KEYSTONE ELECTRONICS CORP.			
www.keyelco.com • NEW HYDE PARK, NY 11040 • Tel (516) 328-7500			
PART NAME		SNAP RIVET	
MATERIAL		NYLON 6/6 UL 94V-2 (BLACK COLOR)	
FINISH		DRN BY	DATE
NONE		BOONE	9.29.06
TOLERANCES		APP'D	SCALE
DECIMAL $\pm .010$ [± 0.25]		RH	5X
ANGULAR $\pm 1^\circ$		DWG NO.	
UNLESS OTHERWISE SPECIFIED		C	
		3442

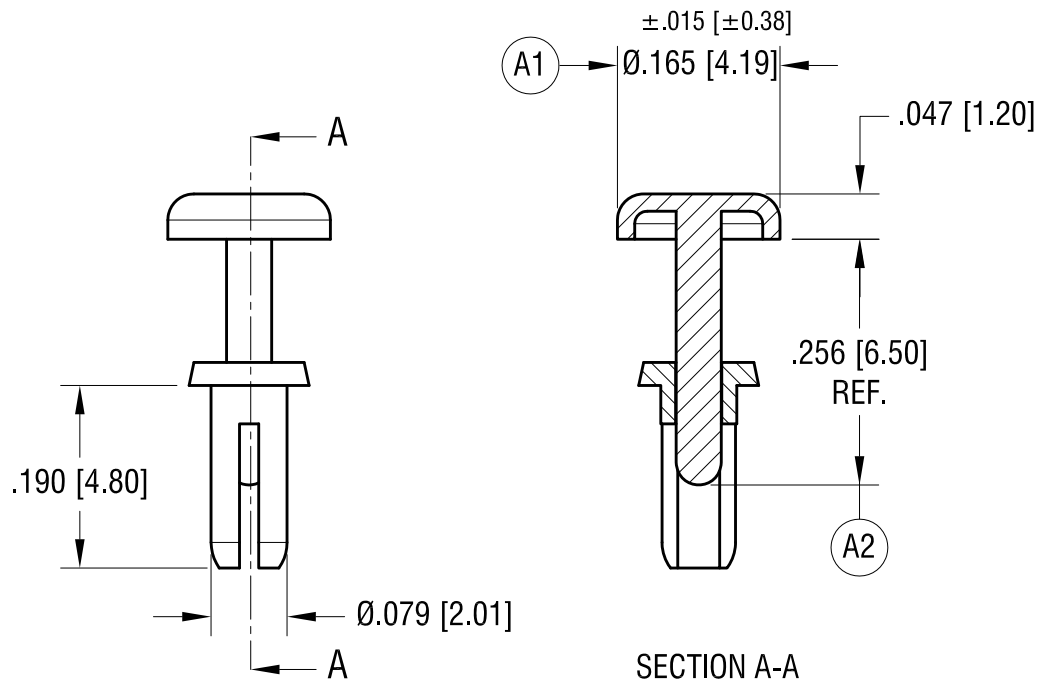
8.27.21	(A1) .165 $\pm$.010, (A2) WAS .220 CHANGE AS PER ECN 21-099	A
DATE	DESCRIPTION	REV.
